G.O. No.	1241	(w)	Press
B.P. No.			Mis. ✓
Dated	10-4-	1877.

Specification to Accompany Estimate for Constructing a Native Regimental School for 70 Pupils.

G.O.Nº 1241 OF 10th APRIL 1877.

STANDARD DESIGN
FOR
FURNITURE
FOR
NATIVE INFANTRY & CAVALRY SCHOOLS.

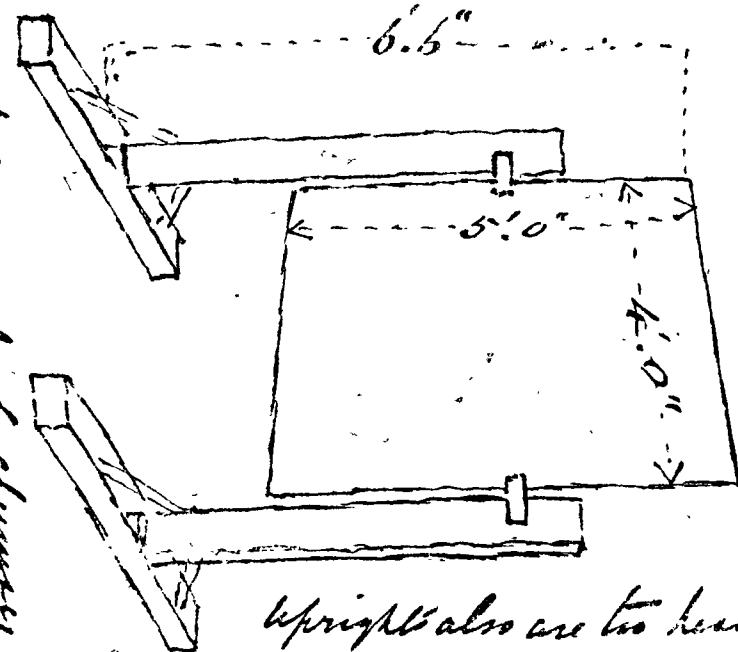
2. The form of the black board, as shown
in the plan, is not quite to my liking.
I should wish the dimensions of the board
to be five feet high and four broad, and
it should be secured to two upright posts,

made to revolve on its centre on two iron
pivots secured to those uprights.

These feet are evidently clumsy &
heavy. M.L.

Uprights also are too heavy.

Black boards — A. Tobe of Teakwood, the board will be 5 ft in height & 4 ft. broad, properly panelled & framed to prevent warping & will be fitted in two upright standards & made to move on Centre pivots of Iron to set at any angle. The standards will rest on pedestals 3 ft long 4 inches broad & 4 inches deep studded on both sides ^{furnished} with Brass or Iron Casters, as shown in drawing & the whole ^{woodwork to be} painted black.
